# Some changes/issues in geometry

Wenqiang Gu

# Restore small CRT panels in the GDML

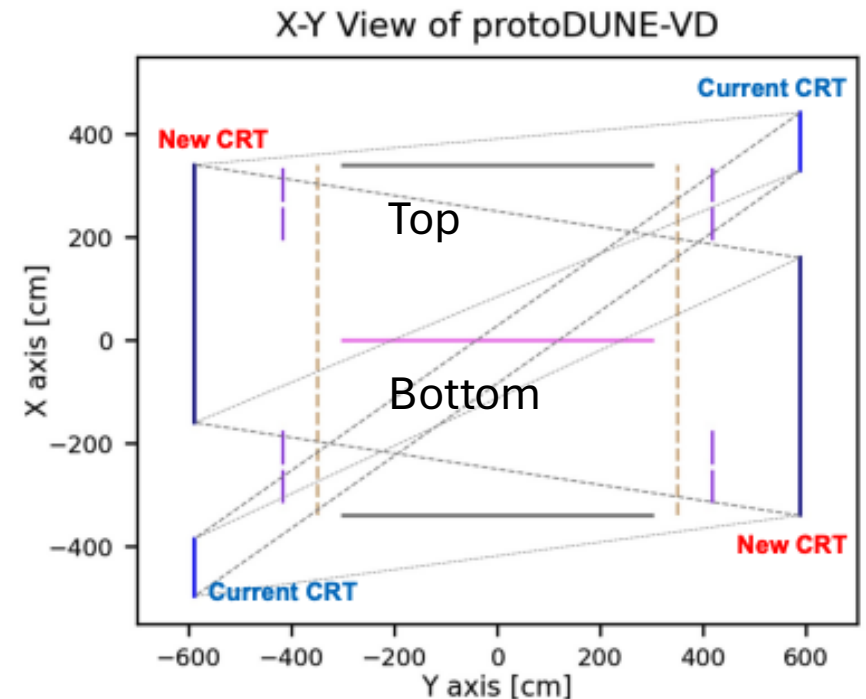
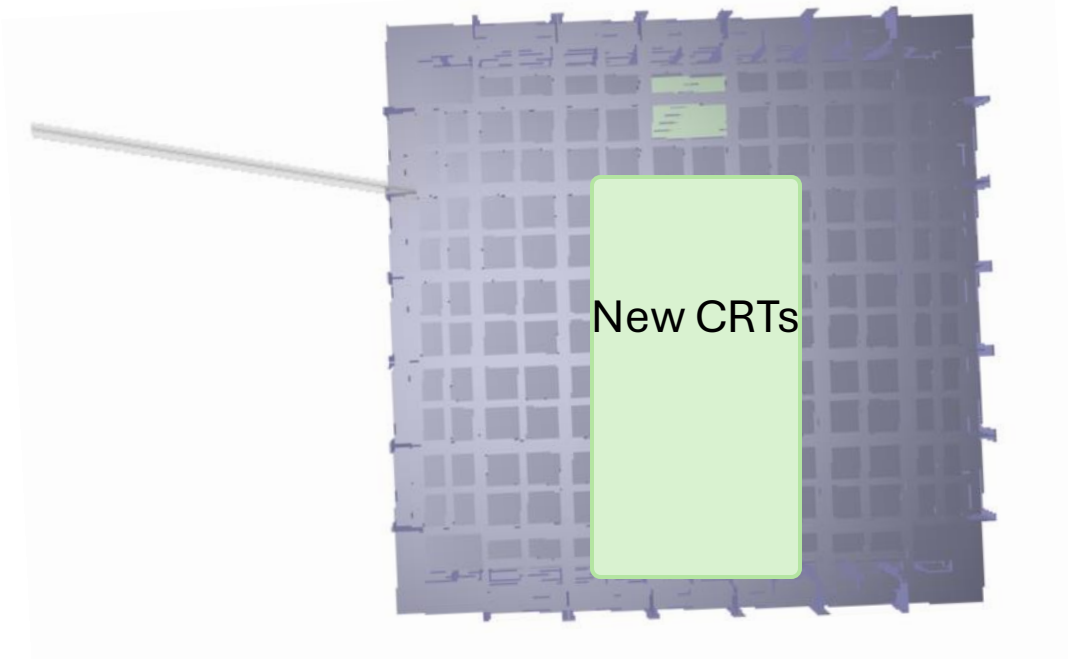
- The small CRT panels are removed given from v3 GDML given “an overlap with beam pipe”, but it appears no such overlap now

```
<physvol>
  <volumeref ref="volAuxDetCRTDPMModuleTop"/>
  <position name="posCRTDPTOPSensitive_1" unit="mm" x="3848" y="5882" z="0"/>
  <rotationref ref="rIdentity"/>
</physvol>
<physvol>
  <volumeref ref="volAuxDetCRTDPMModuleBottom"/>
  <position name="posCRTDPBOTTOMSensitive_1" unit="mm" x="-4406" y="-5882" z="0"/>
  <rotationref ref="rIdentity"/>
</physvol>
```

# Asymmetric boundaries at top and bottom

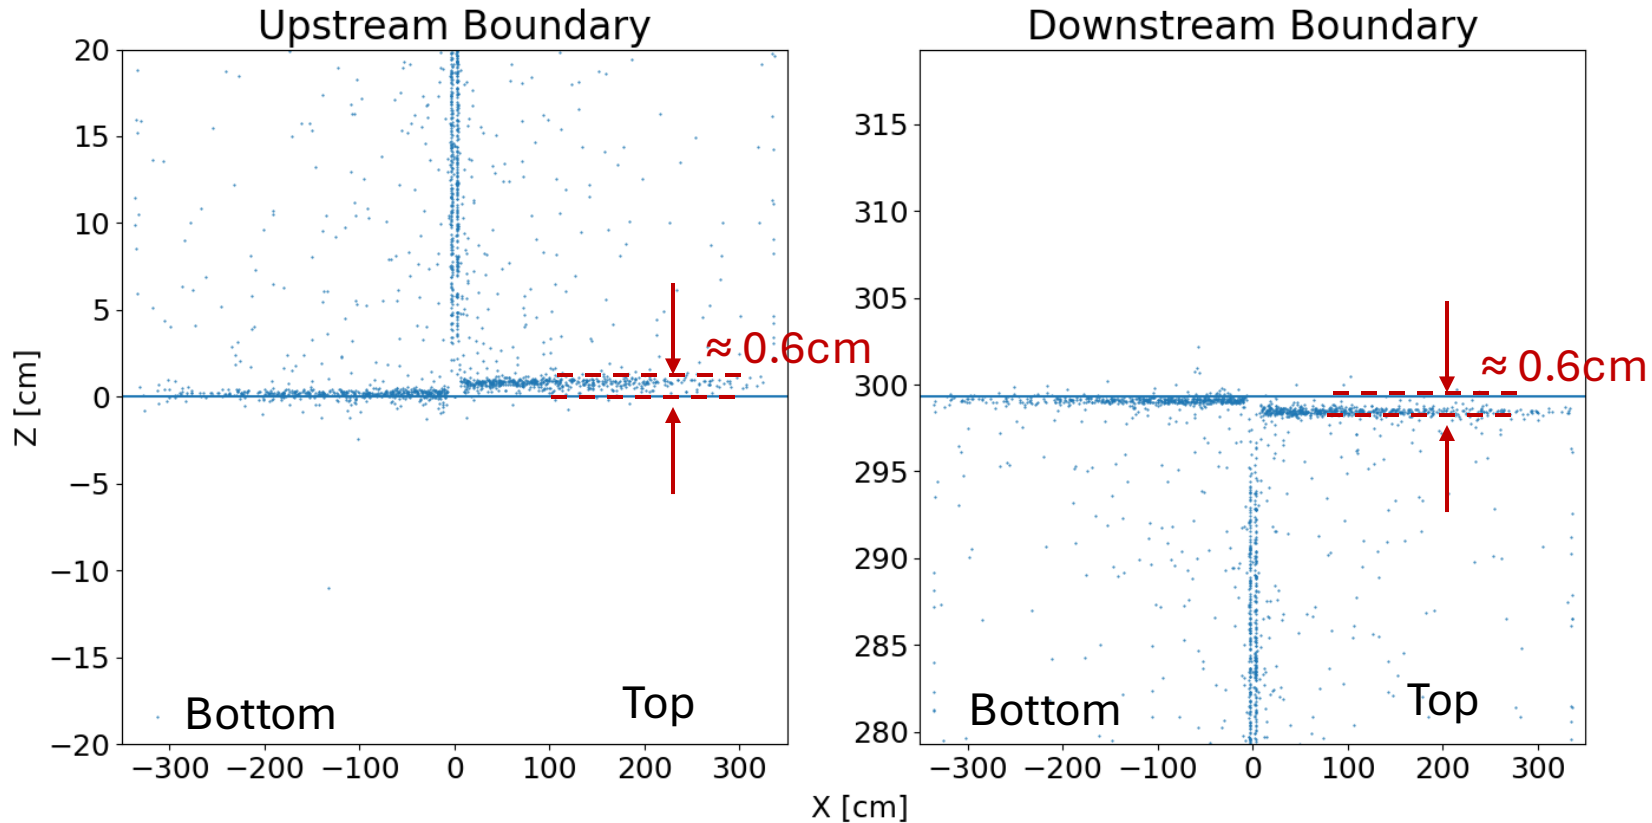
- Simulated energy depositions are not symmetric at top and bottom
- Indicates an offset in the TPC geometry implementation

# Solution: add the offset to <physvol>

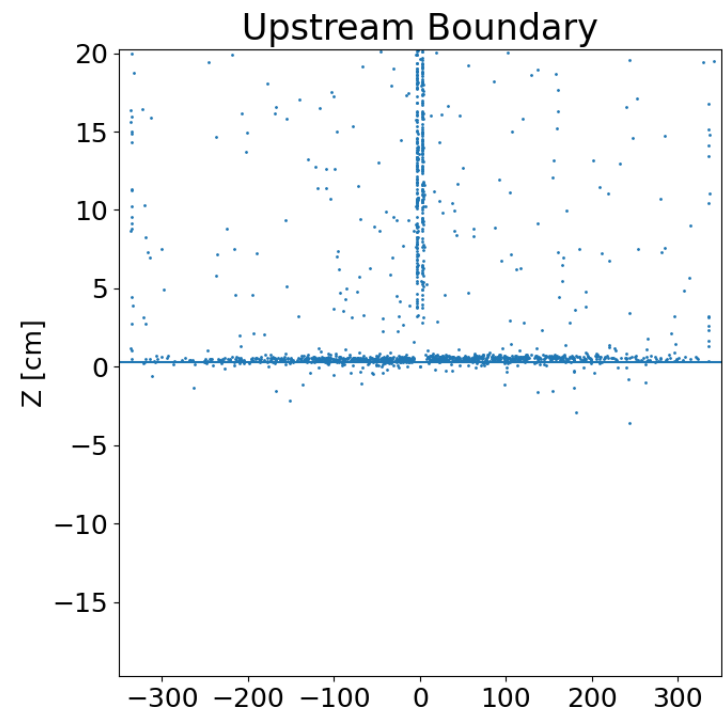
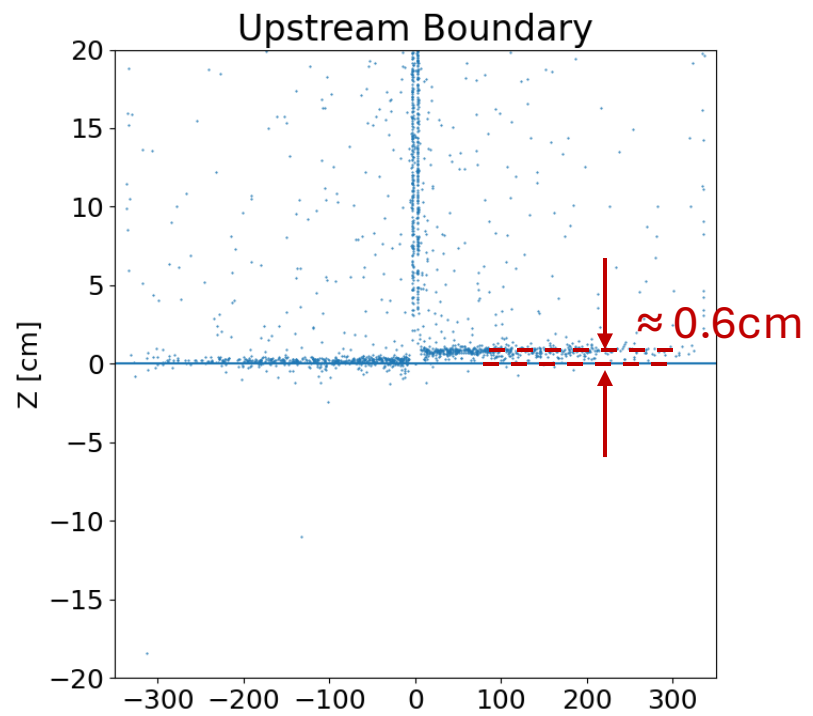
- Given the borderCRP (=0.6cm), offsetY and offsetZ are calculated for each volTPC
- However, when volTPC is rotated for a bottom one, the offset would be translated to an asymmetry

```
<volume name="volTPC0">
  <materialref ref="LAr"/>
  <solidref ref="CRM"/>
  <physvol>
    <volumeref ref="volTPCPlaneU0"/>
    <position name="posPlaneU0" unit="cm"
      x="169.23" y="0" z="0"/>
    <rotationref ref="rIdentity"/>
  </physvol>
```

```
<physvol>
  <volumeref ref="volTPC0"/>
  <position name="posTopTPC-0" unit="cm"
    x="152.28" y="-252.45" z="-74.55"/>
</physvol>
<physvol>
  <volumeref ref="volTPC0"/>
  <position name="posBotTPC-0" unit="cm"
    x="-192.28" y="-252.45" z="-74.55"/>
  <rotationref ref="rPlus180AboutY"/>
</physvol>
```
